RESPONSES TO BETA GROUP, INC. TRAFFIC IMPACT ANALYSIS PEER REVIEW COMMENTS
DATED AUGUST 30, 2021

TURNING MOVEMENTS FOR TRASH TRUCK

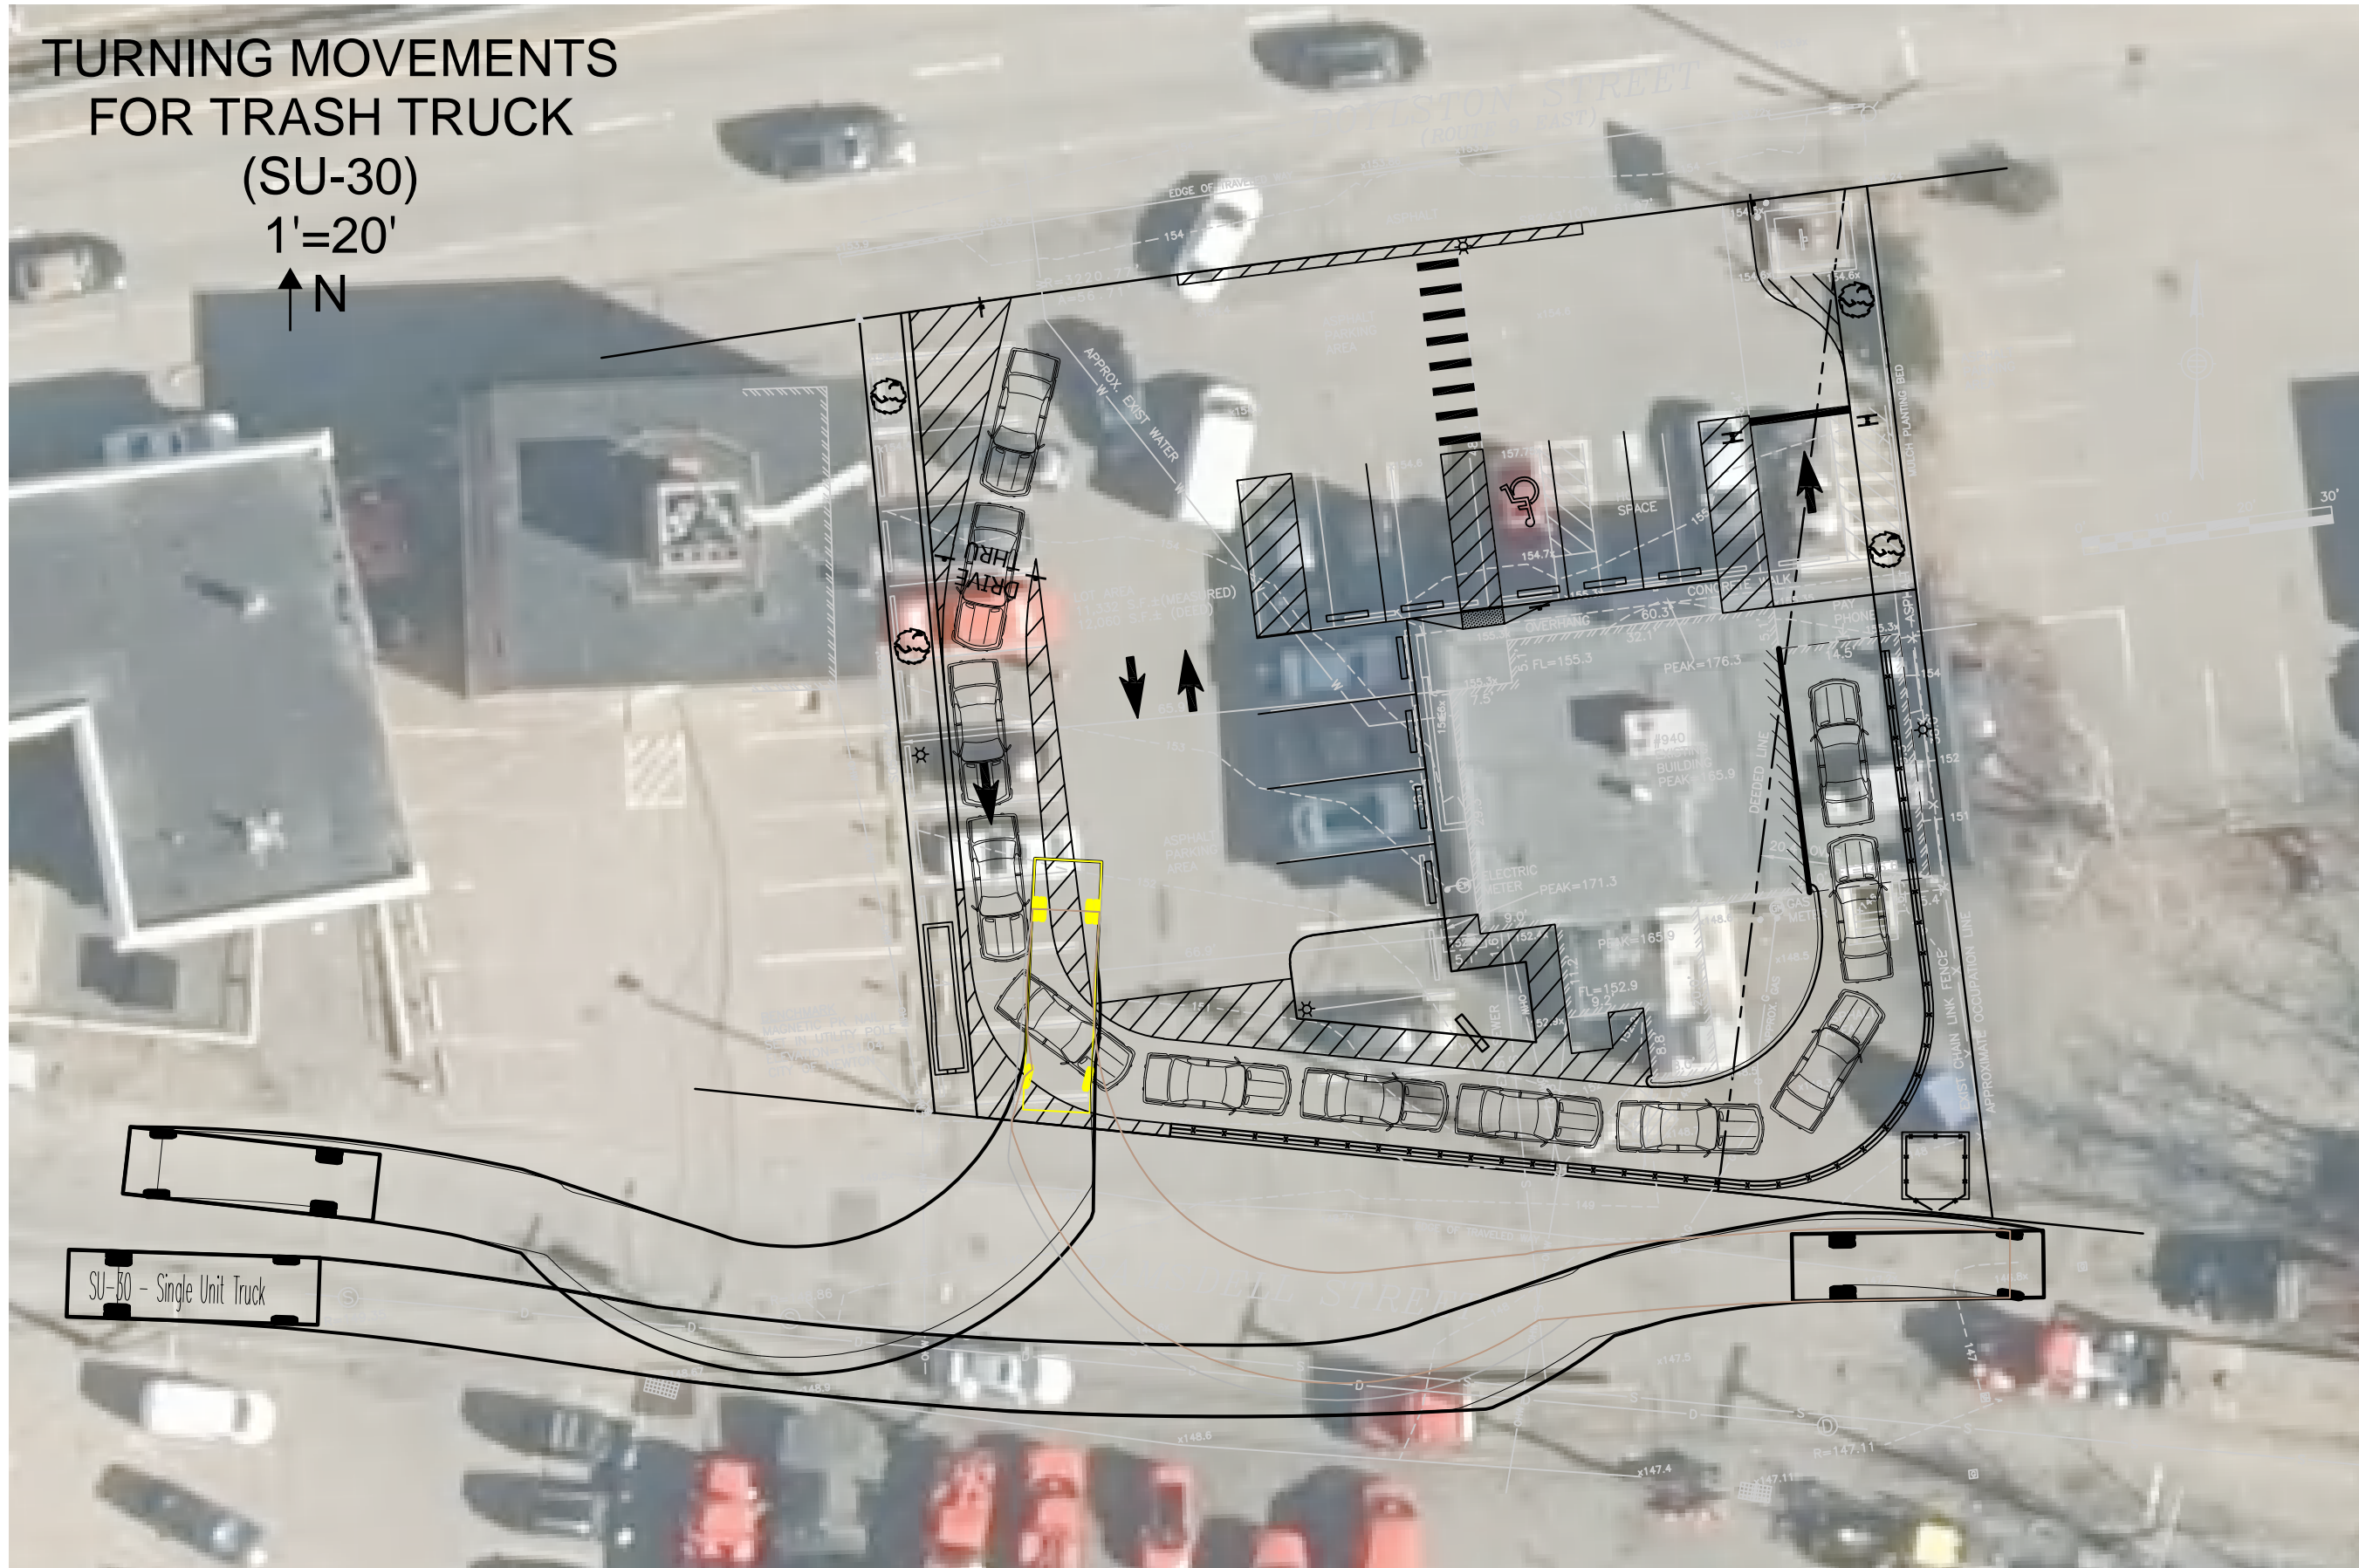
BETA2: Though deliveries are proposed outside the peak commuter hours, Ramsdell Street is a dead-end street with no secondary outlet, which is a concern for larger vehicles particularly large trucks (semi-trailer). What is the typical size of a delivery truck for this site? Please provide a turning template of the delivery truck including the dumpster truck that will access Ramsdell Street. It is important to note that we observed a tractor trailer making a delivery at the Wellesley Dunkin' site within the Route 9 westbound shoulder during the morning peak period.

PARE2: A turning assessment for a WB-40 semi-trailer and a SU-30 dumpster truck was performed and is provided. The semi-trailer has adequate space to enter from Boylston Street and exit to either Boylston Street or Ramsdell Street. The dumpster truck appears to be side-loaded and accesses the dumpster in a similar manner as it does today.
